Water Resources Department

FINAL ORDER

The Special Standards Request Form you submitted for owner: Rivergrove Water District, Start Card number 201165 (Well #2), is hereby approved for the following: Installing and swage a minimum 1/8" thick stainless steel patch over weld and grouting from 25 feet back to land surface. Your Special Standards Request Forms is enclosed.

Special Standards Request Form

Rivergrove WD Well 2 12" casing drift

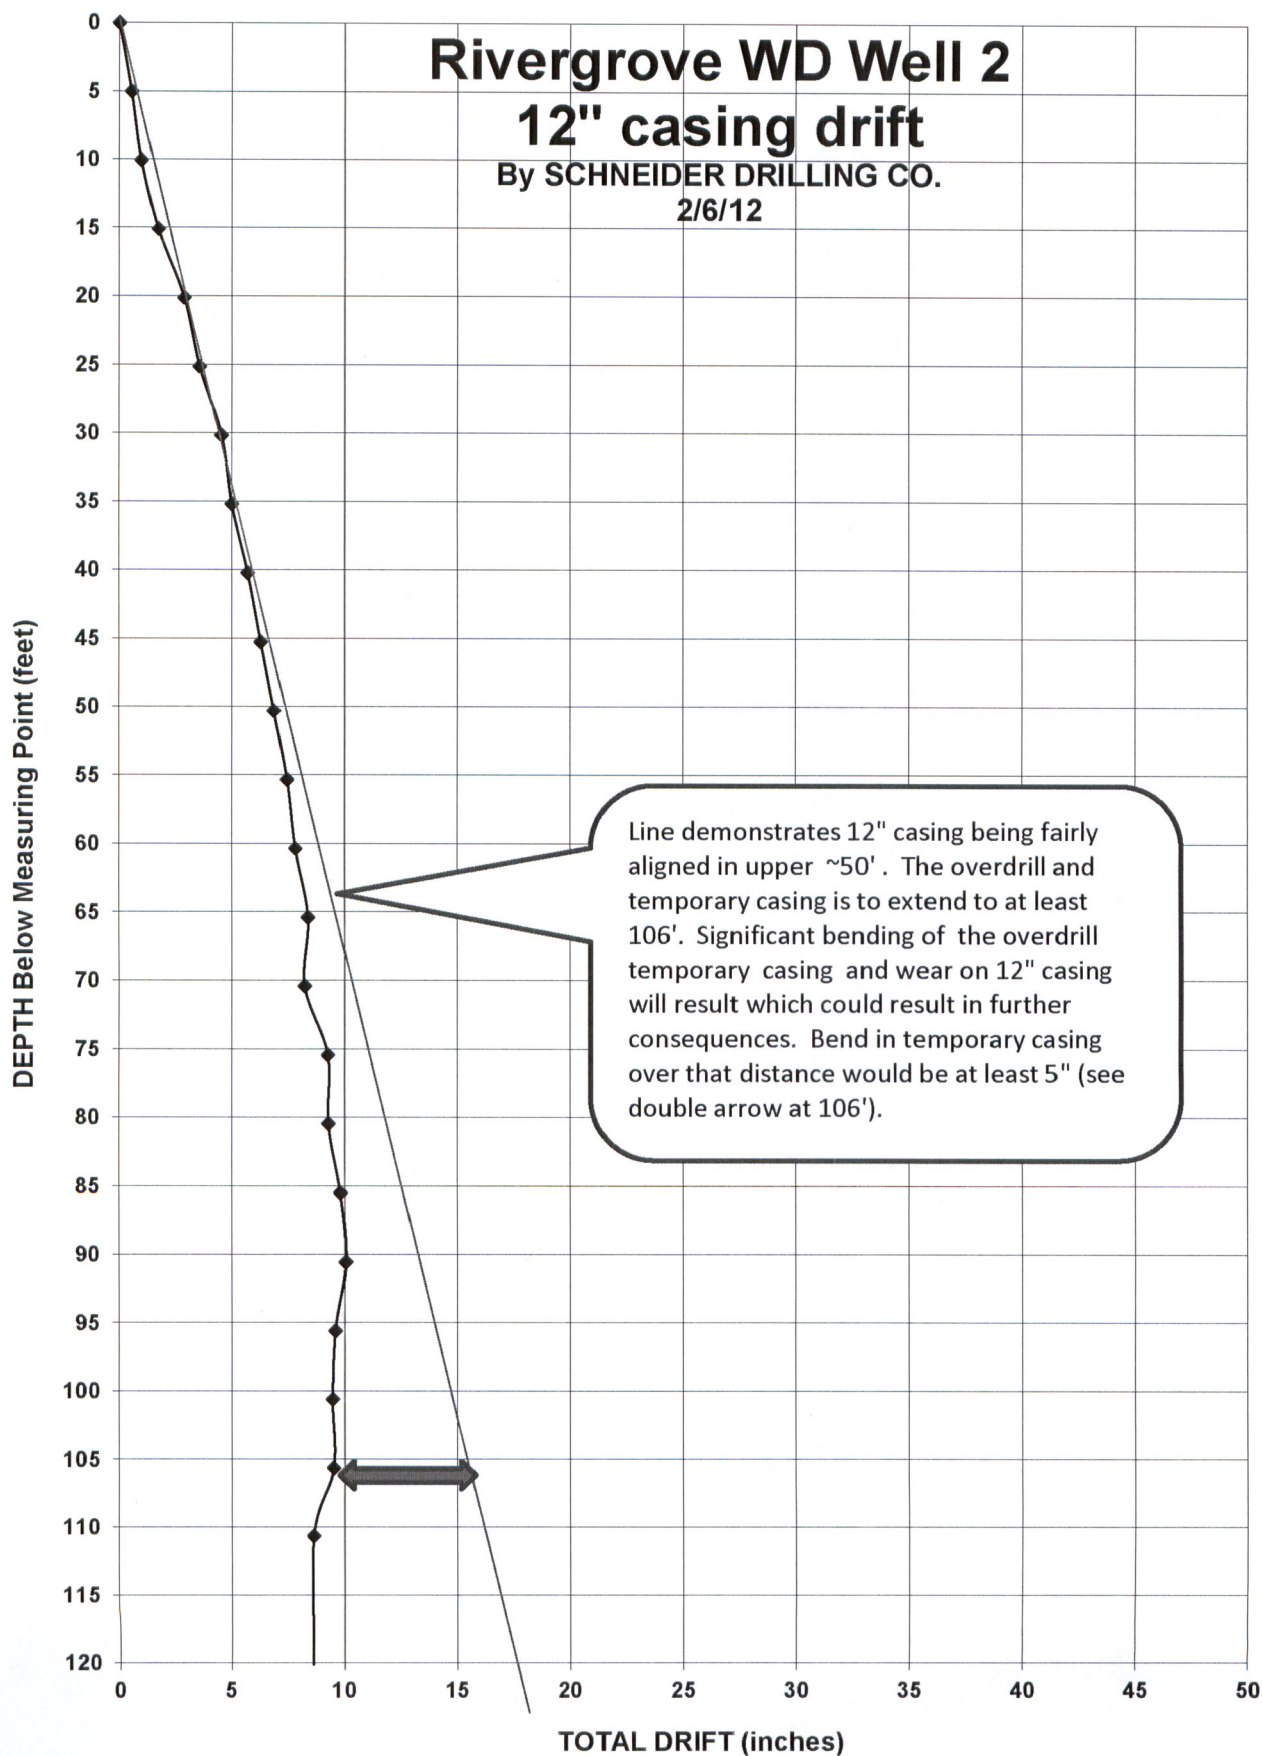
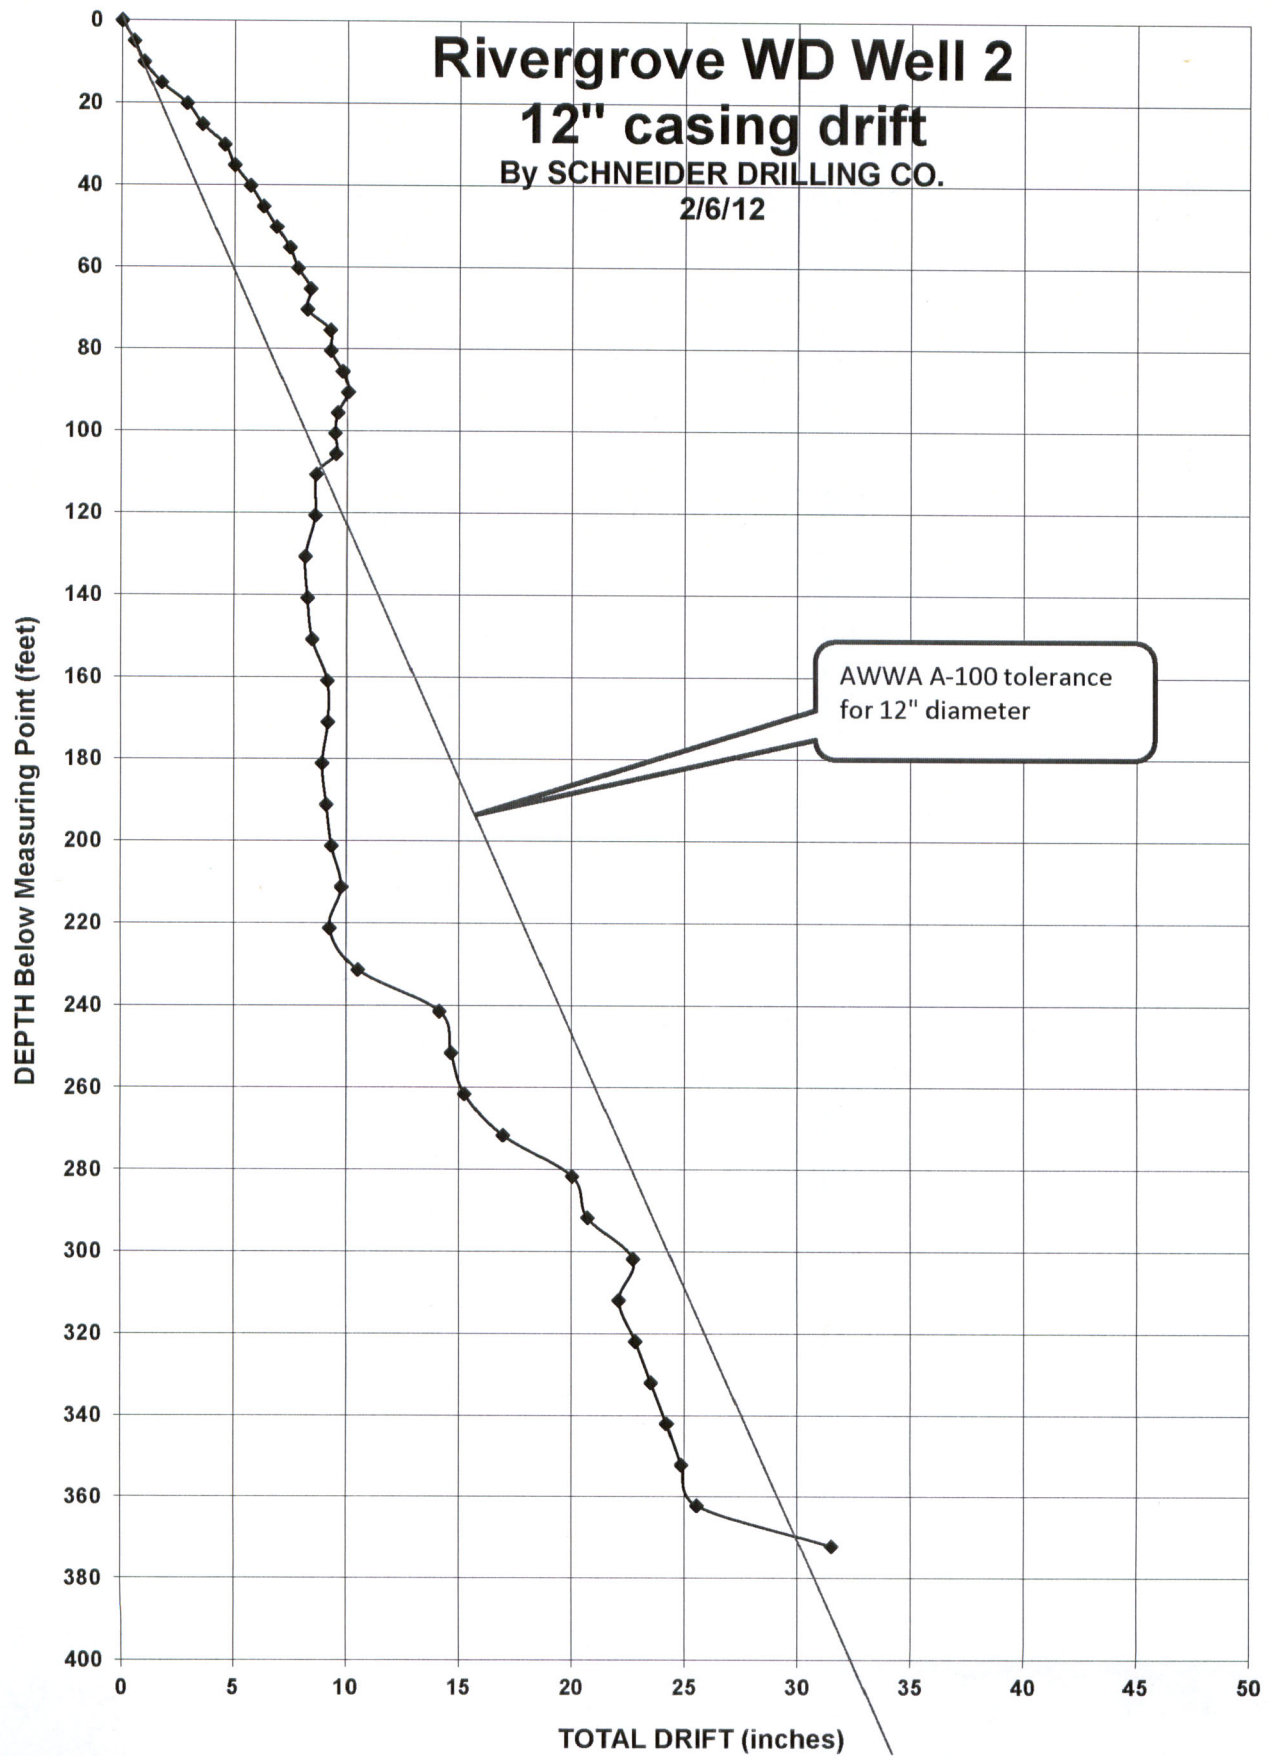
survey(s). We overdrilled to 25', found weeping weld at ~11' bgs. Ran drift check; hole below ~50' has excessive bend.

Rivergrove WD contracted us to overdrill their Well #2 and replace its seal. As we started to overdrill, our driller noticed things didn't seem right so he pulled up and as his tools pulled cleared he noticed the 12" existing casing had moved over against the 20" temporary casing he had installed to 4'. That gave us concern about alignment so we ran a drift survey (see attached plots). When he removed the drift plummet from the 12" casing, he noticed drill mud on it. He then ran a camera down and observed mud had seeped into the well at an apparent weld connection ~11' bgs. There is no visible separation of the casing; only that mud had leaked through the connection. We do not want to proceed with overdrilling any further given the misalignment that we discovered. To the best of our knowledge, this work was requested by the District only because the seal on the well had been mentioned on a Health Department survey as a potential concern. Our understanding from MSA, their consultants, is that there has not been a contamination issue with this well.

Install and swage a minimum 1/8" thick stainless steel patch over weld. Grout well from 25' back to surface. Do

not overdrill or replace seal any deeper.
